Section 92 Request for Information: BUN60440759 – 362 Jones Road, Drury			
Item	Information Request	Applicant's Response (12/02/2025)	Council Response (as dated)
<b>1. Planning</b>			
1(a)	<p>The application details consultation undertaken with Ngāti Tamaoho. The following mana whenua groups are also listed as potentially having an interest in this area.</p> <ul style="list-style-type: none"> <li>- Ngāi Tai ki Tāmaki</li> <li>- Ngāti Maru</li> <li>- Ngāti Pāoa</li> <li>- Ngāti Tamaterā</li> <li>- Ngāti Te Ata</li> <li>- Ngāti Whanaunga</li> <li>- Te Ahiwaru - Waiohūa</li> <li>- Te Ākitai Waiohūa</li> <li>- Waikato - Tainui</li> </ul> <p>Please confirm if consultation has also been undertaken with these groups, and if so, provide evidence of consultation. Contact details can be found here: <a href="https://www.aucklandcouncil.govt.nz/building-and-consents/resource-consents/prepare-resource-consent-application/Pages/find-hapu-iwi-contacts-for-your-area.aspx">https://www.aucklandcouncil.govt.nz/building-and-consents/resource-consents/prepare-resource-consent-application/Pages/find-hapu-iwi-contacts-for-your-area.aspx</a></p>	<p>Consultation has not occurred with these mana whenua grou

Figures relating to item 5(c):

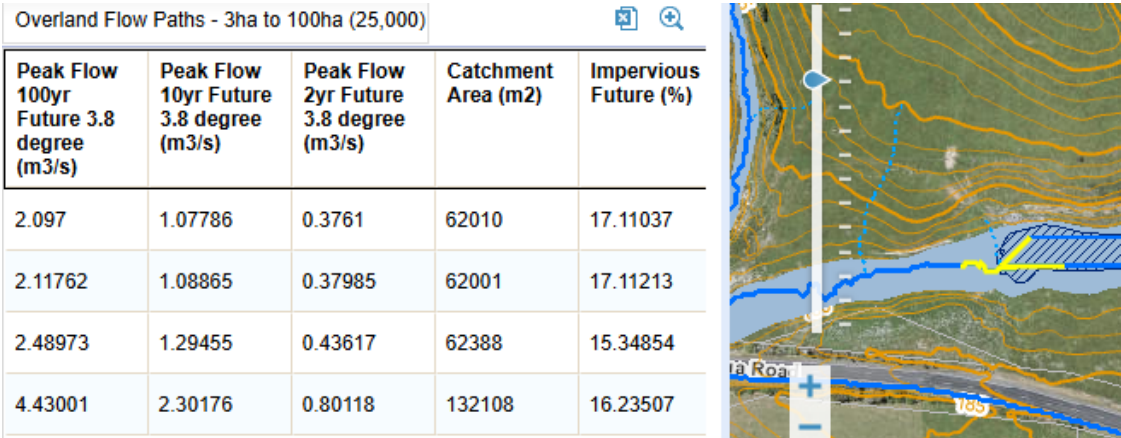
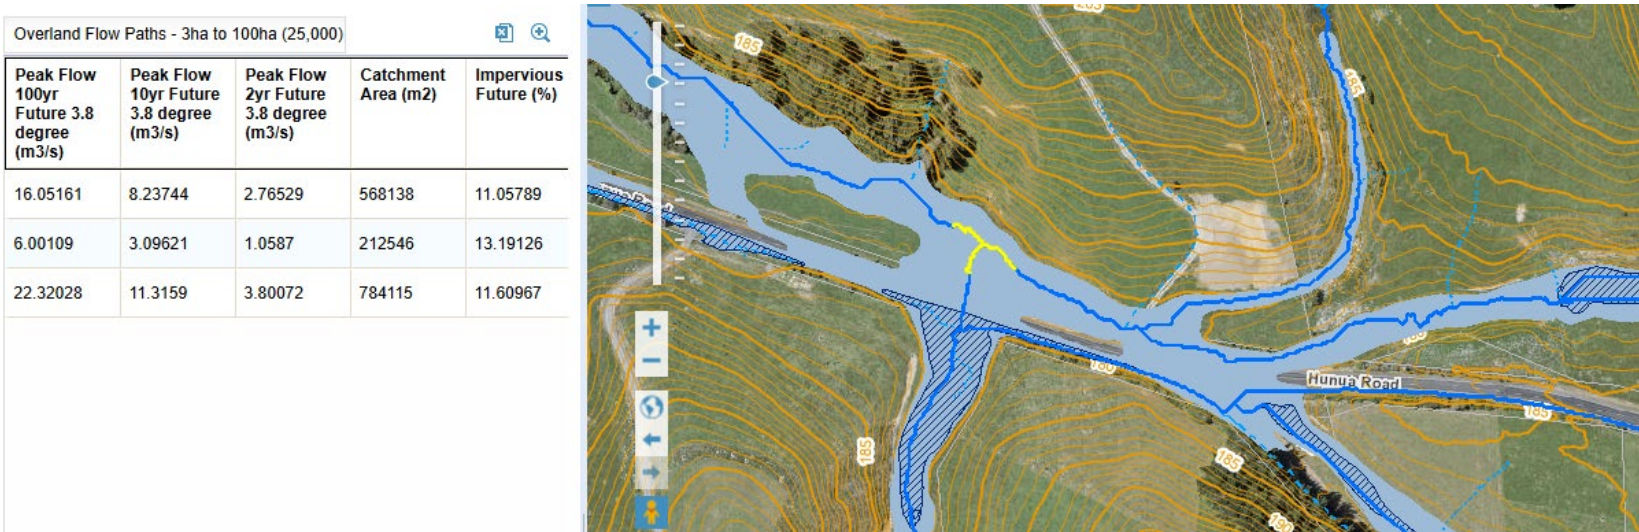
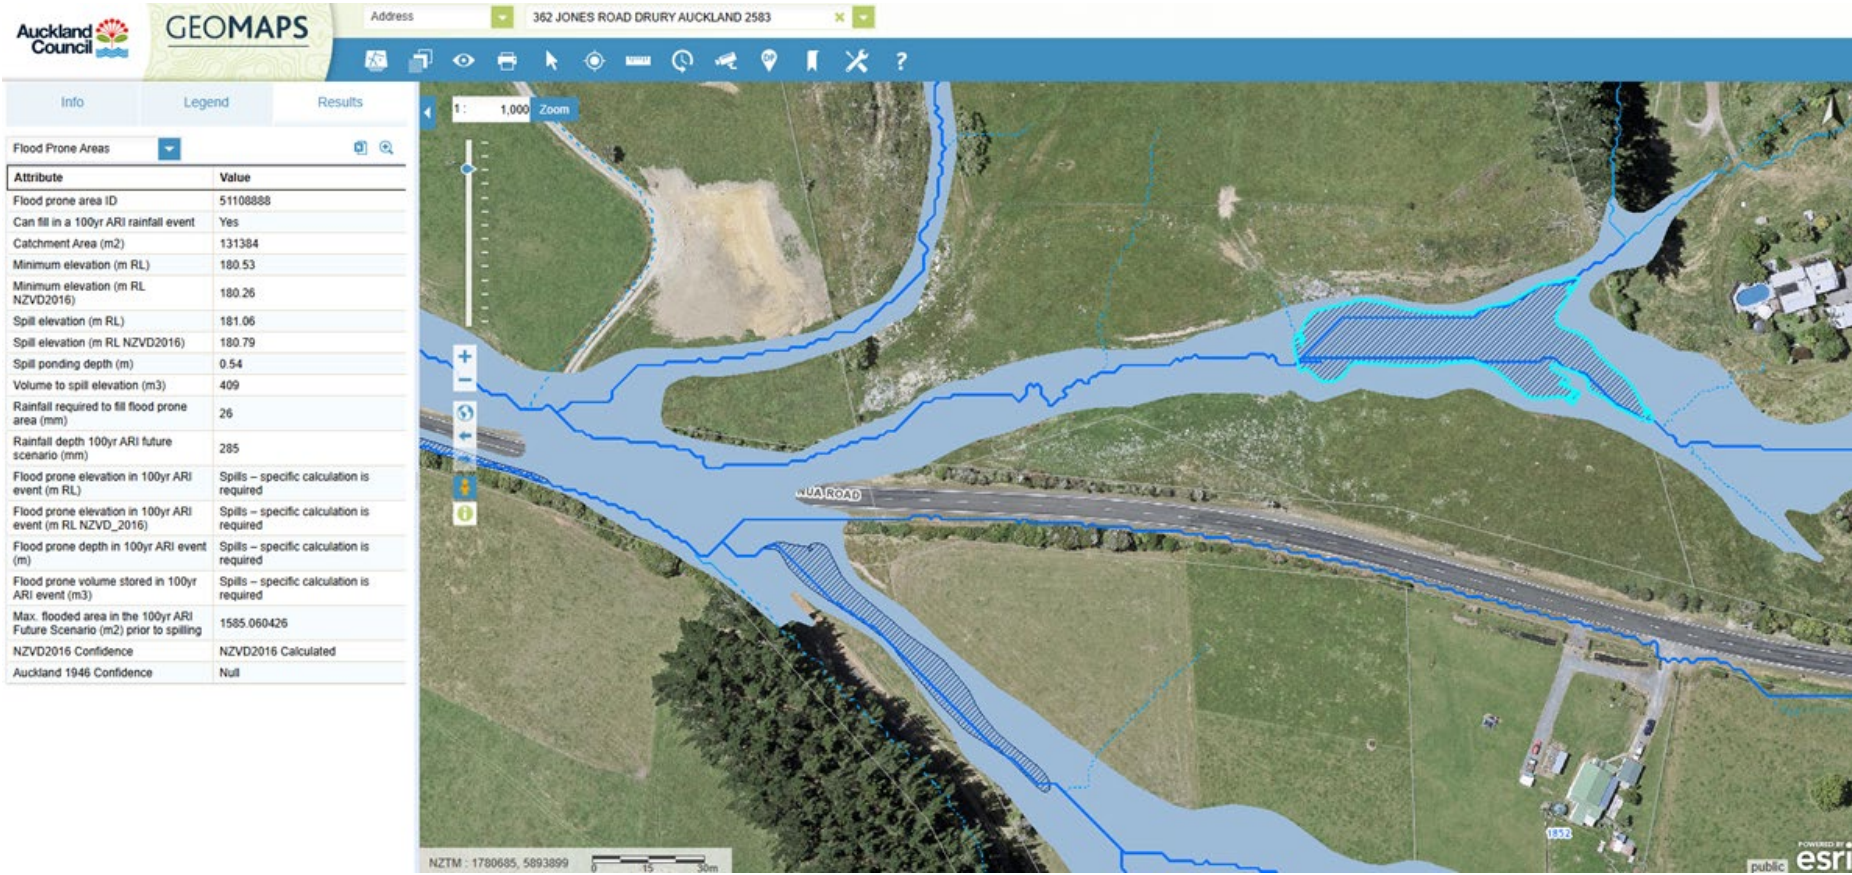
5(c)	<p>It appears that the proposed bridge abutments encroach into the existing floodplain extents. It is accepted that the removal of the existing culvert may result in a decrease in flood levels upstream, however the overall effects on flooding in the area following the installation of the proposed bridge structure is unclear.</p> <p>Provide a hydraulic assessment, including the comparison of the pre-development and post-development flooding extents, to demonstrate that the proposed bridge will not increase upstream or downstream flood levels (beyond the land owned or controlled by the Applicant).</p>	<p><b>Fraser Thomas Ltd</b></p> <p>The bridge is replacing an existing culvert. Section 6.8.3 of our report states that the bridge will be designed to take the 1% AEP storm event with allowance for climate change without heading up. Hence, upstream flood levels will be reduced, as the bridge replaces an existing 600dia culvert. The catchment at the existing culvert is approximately 13.2ha as shown in Figure 1 <a href="#">under this table</a>. A flood prone area is present behind it with a storage volume of 409m<sup>3</sup> to the spill point (see Figure 4), which takes only an estimated 26mm of rain to fill (compared with 100yr rainfall of 285mm), meaning that there will be very little attenuation of rainfall behind the existing culvert in a 100yr event. Runoff continues down a gully on to the neighbouring site, combining with other overland flowpaths (OLFPs) from the subject site and surrounds to form a much larger OLFP (78.4ha) area within 290m of the existing culvert (see Figure 2) . Over this distance, there are no houses or any other buildings that could be affected. Further downstream, the OLFP catchment continues to increase and hence any increased flows associated with the culvert to bridge change, become negligible in comparison with flows from other sources. Hence, any increased flows down the gully from replacement of the existing culvert with a bridge are not expected to cause any adverse effects on neighbouring properties.</p>	<p>18-02-2025 DS - <b>Resolved</b></p>

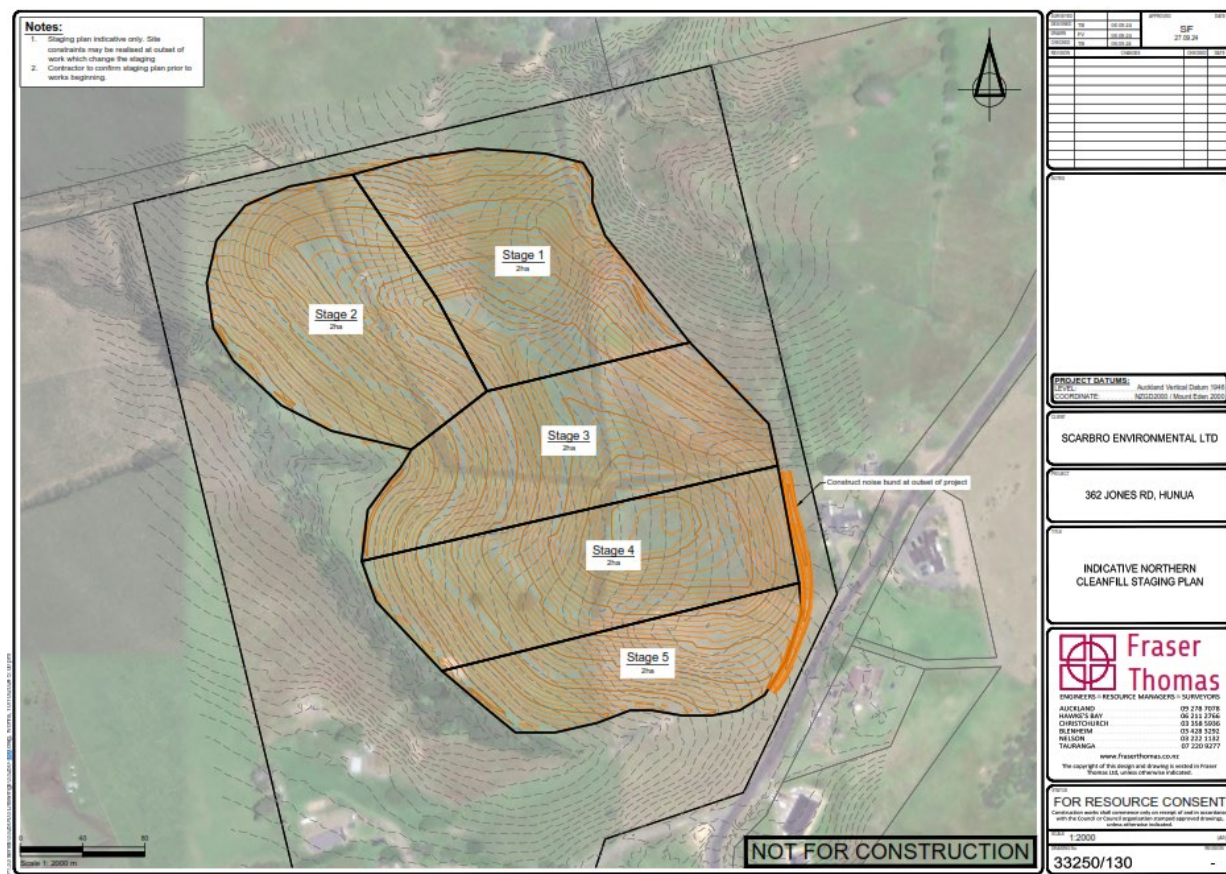
*11 (a) The proposal is described in section 2 of the Assessment of Landscape and Visual Effects (ALVE) as a series of 'bullet points'. With the exception of the visual simulations, no figures have been included in the assessment to illustrate the detail of the proposal. To fully understand the proposal, it is recommended that figures illustrating:*

- 1. the staging of the proposal in relation to the contextual landscape and potentially affected individuals;*
- 2. how the proposed fill areas relate to the contextual landform (in addition to a plan, this should also include extended cross sections based on those contained in the lodged engineering plans to determine whether the slopes of the proposed landform are sympathetic to / are consistent with the existing topography);*

Paragraphs 104-130 of the AEE outline the proposed staging. The managed fill deposition will be staged so that a maximum area of 2ha is being filled at any one time. Preliminary staging plans are shown on drawing 33250/130. The staging is indicative only, as the filling will be an iterative process, with filling areas changing as required to build the final platforms. The staging plan may also need to be changed as site constraints and operational constraints are realised during either detailed design or once SEL has established on site.

At the pre-application meeting Auckland Council agreed that staging could be responsive rather than prescribed particularly for Erosion and Sediment controls, but a plan has been included in the application. Staging is also controlled by the maximum 2ha area of exposure at any time. Refer to Figure 1 overleaf.

**Figure 5: Noise bund location plan**

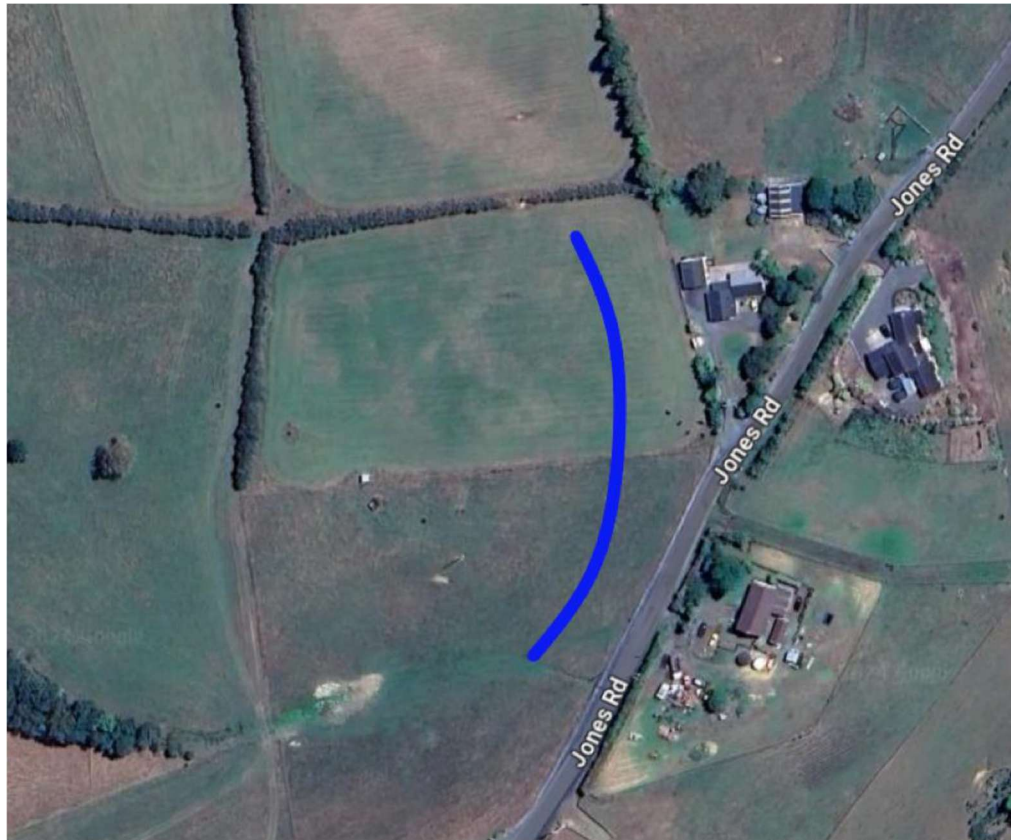
*11(n) With regard to #332, the staging plan included as 33250/130 in the lodged plans shows a noise bund constructed along the western boundary of this property. It is recommended that a cross section be included showing how the noise bund relates to the dwelling within #332, and the assessment should be expanded to include comment on this element. Similarly, a bund is proposed to the west of #353. It is recommended that*

a cross section be included showing how the noise bund relates to the dwelling within #353, and the assessment should be expanded to include comment on this element. Also, is it proposed that the bund be planted?

An earth bund shall be constructed to provide acoustic screening to 332 Jones Road and 353 Jones Road to the east of the site. The bund shall be at least 160m long, 3m high and constructed 20-25m in from the eastern site boundary. Figure 5 illustrates the approximate location of the proposed earth bund.

### Sheet 3-2

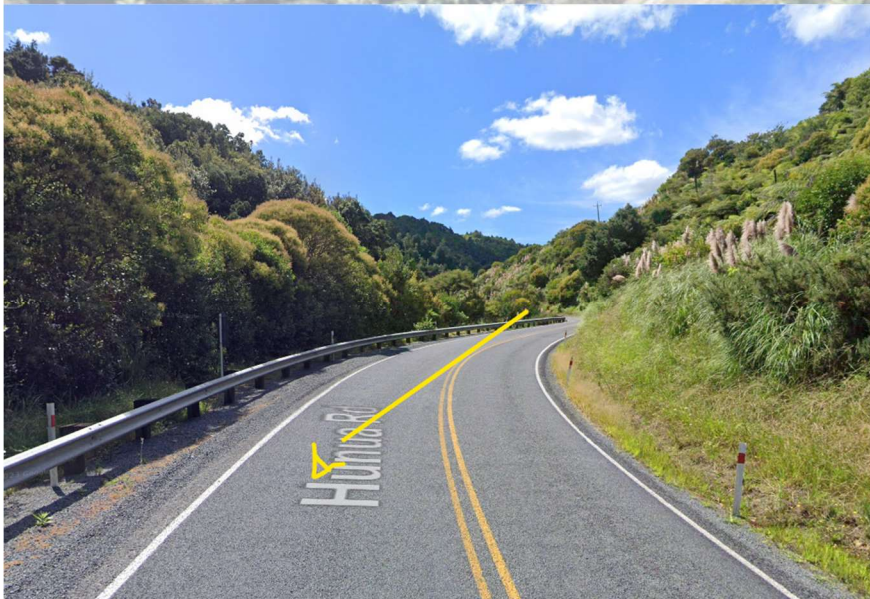
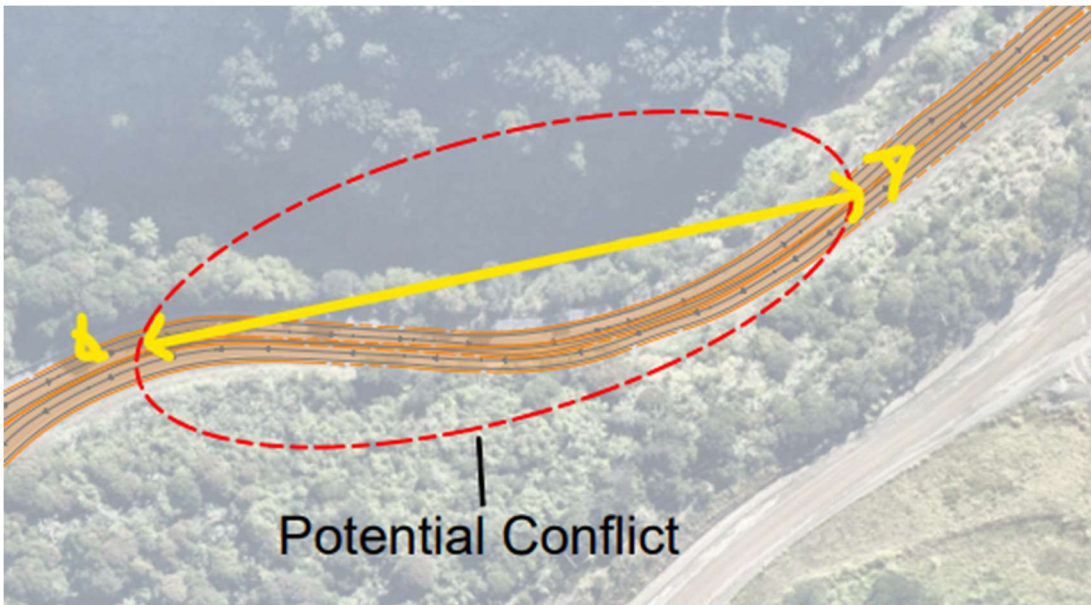
The worst case is on sheet 3-2 where opposing truck movements may get caught out, but this could be mitigated with signs and visibility.

Has quite significant overlap and could cause a potential two-way conflict with the Ardmore Quarry truck movements. Since there is no way to coordinate the two operations, some mitigation may be necessary. We would be wanting road narrows signs (PW-43) and/or information sign (IG type white with black border) to warn truck drivers of the narrow section. We also would be keen to hear how the applicant would improve these sightlines and make sure trucks slow down appropriately.

### Sheet 3-5

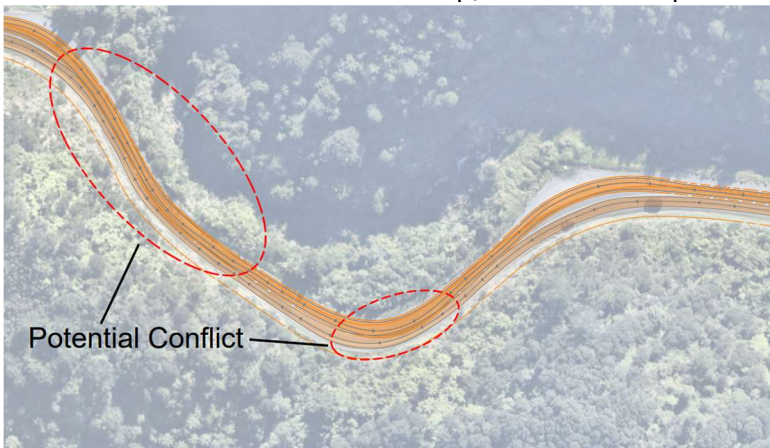
These are short sections with overlap, with reduced speeds then opposing truck movements should be okay.
